TRAFFIC MANAGEMENT PLAN

WA1478. MOUNT SHADWELL SCORIA QUARRY

Prepared by:
NAM P/L
10215 Princes Highway
Allansford 3277

14TH October 2024

DTP. Crossover design.

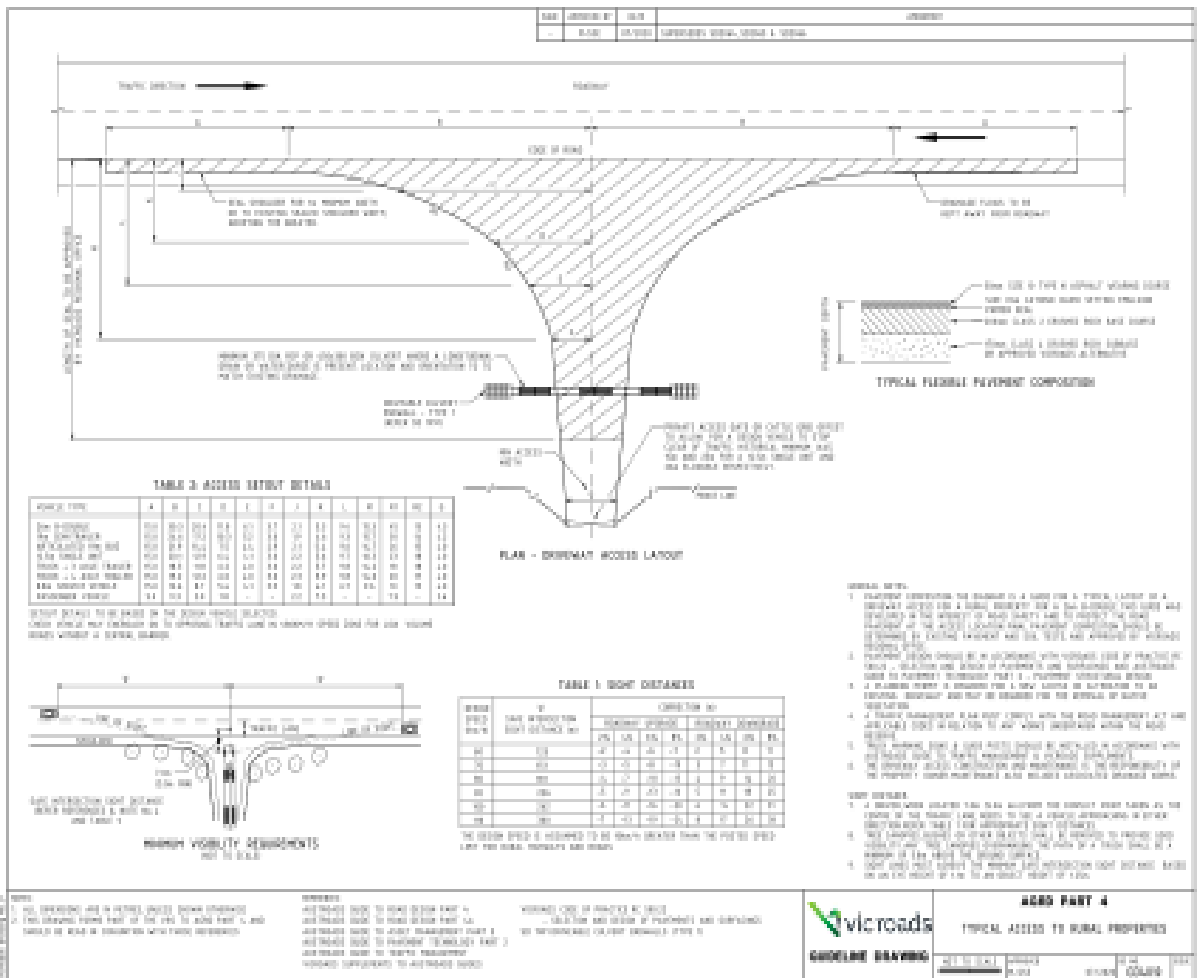
- The crossover will need to be upgraded according to the attached GD4010 (I remember you suggesting that the largest vehicle accessing the site would be a truck and dog, so use the set out dimensions in Table 2 relating to truck and 4-axle trailer). Probably need to widen it to the south to avoid having anything to do with that power pole (expensive pastime – playing with those!)

- It looks like there's a drain on that side of the road, so a culvert will be needed, installed at the same alignment (horizontally and vertically) as the current one, and fitted with driveable end walls on both ends.

- Sealing of the crossover for 10 metres from the road would be preferable.
- The gate looks to be indented into the property (allows a vehicle to be parked fully off the road while the gate is opened or closed), which should be repeated.

- **Quarry entry, (crossover) from the Mortlake Ararat Road.**
The Crossover will be constructed to the design provided by DTP.
Please refer to attached DTP Crossover design.
- **Culvert.**
A culvert to DTP specification will be installed.
- **Sealing.**
In accord with DTP. recommendation the crossover will be sealed.
- **Indent.**
The indent depth will be increased to 20m to allow for trucks and trailers to park safely off the Mortlake-Ararat Road when accessing the quarry.
- **Visual site lines to quarry entry-exit from Mortlake Ararat Road.**
Please refer to DTP advise and attached photos, pages 7 & 8.
- **Speed Limits and Signage.**
DTP made no requirements for speed limits or signage.
